Detailed Site Plan Vista 95 Logistics Center

DSP-22009

SUBJECT: Detailed Site Plan DSP-22009
 Type 2 Tree Conservation Plan TCP2-026-2022
 Vista 95 Logistics

Figure 1: Site Plan

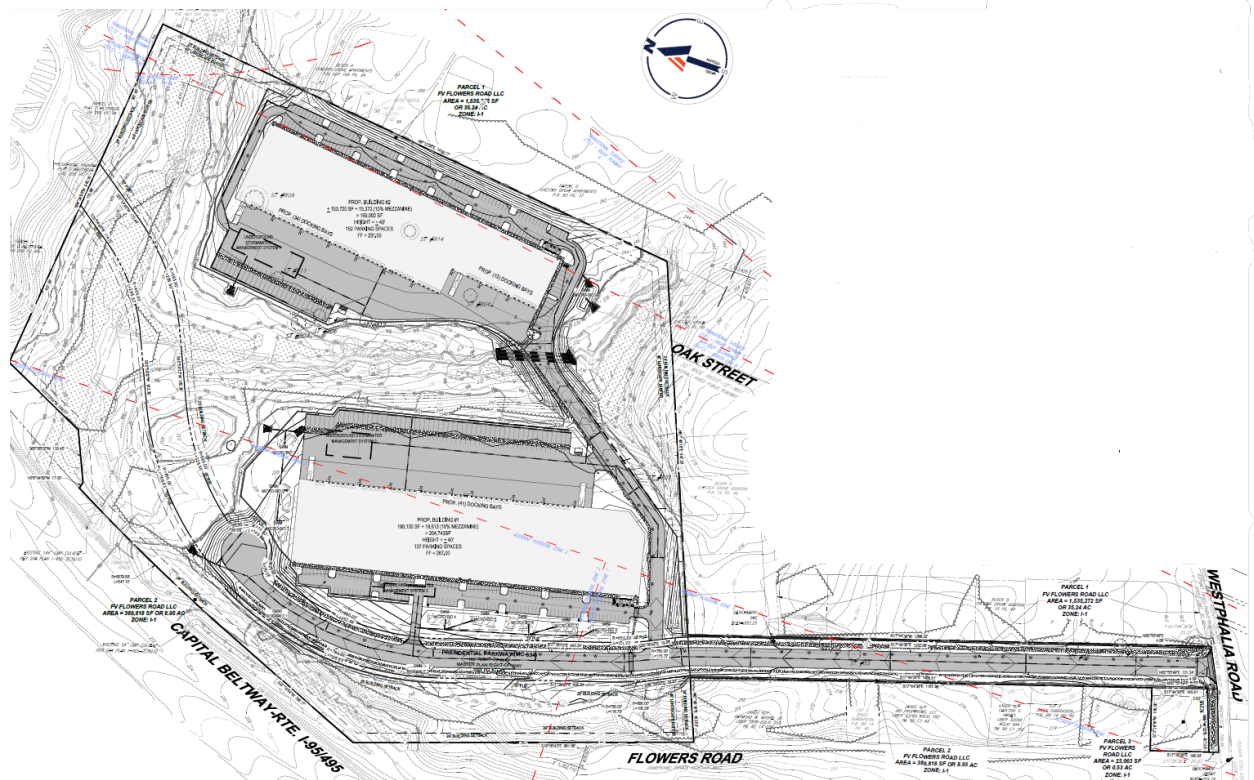
A sidewalk is adjacent to the drive aisle on-site and connects the two buildings, in accordance with the PPS. A 15- to 16-foot noise attenuation fence is proposed near Building 1, to mitigate noise on the property. In addition, the applicant has proposed to construct privacy fencing along both sides of the portions of future Presidential Parkway to Westphalia Road, on the southern and eastern boundaries of the property, to screen views into the site. However, the fence locations are not clearly delineated on the plan and should be shown for clarification.

1. Prior to certification, the detailed site plan (DSP) shall be revised as follows:
 - a. Revise the line type of the northern property boundary of Parcel 3 to be consistent with other property boundary line types.

- b. Label the area of right-of-way dedication for Westphalia Road and Presidential Parkway (MC-634).
 - c. Revise General Note 32 to separately indicate the area of dedication for each public right-of-way.

- d. Clearly show the locations of the noise wall and the vinyl fence on the site plan.
 - e. Provide the top and bottom elevations on the retaining wall.

- h. Revise the DSP sheets to reflect the site design layout, as shown in Attachment A (Updated Circulation Plan).
 - i. Revise the DSP to display the dedication of right-of-way along the property's frontage on Westphalia Road, in conformance with previously approved Preliminary Plan of Subdivision 4-21013.

Figure 2: Architectural Elevations

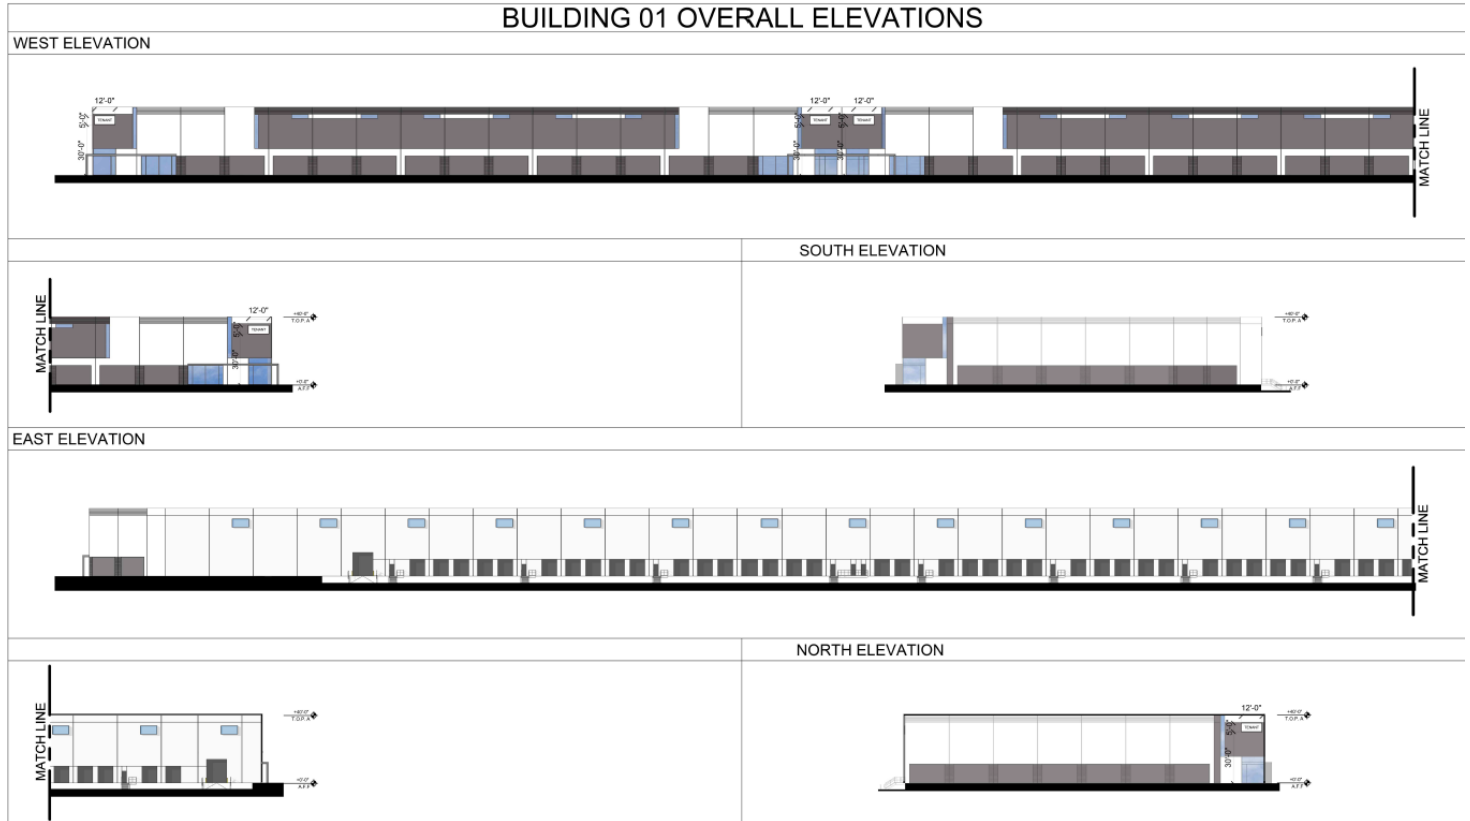
Both Building 1 and Building 2 include similar materials and their façades are broken up using color and massing, in addition to floor to ceiling windows near the primary building entrances and by using windows along the roof line to provide natural light. The elevations submitted do not clearly indicate the materials to be used and indicate that materials shown on the elevations are preliminary. The materials should be shown, and a condition is included herein, to revise the building elevations to clearly indicate the materials used.

- f. Clearly indicate the building materials proposed on the architectural elevations.
 - g. Provide a revised sign table listing the number of signs, size, material, lighting, and their location on the façades, in accordance with the applicable standards.
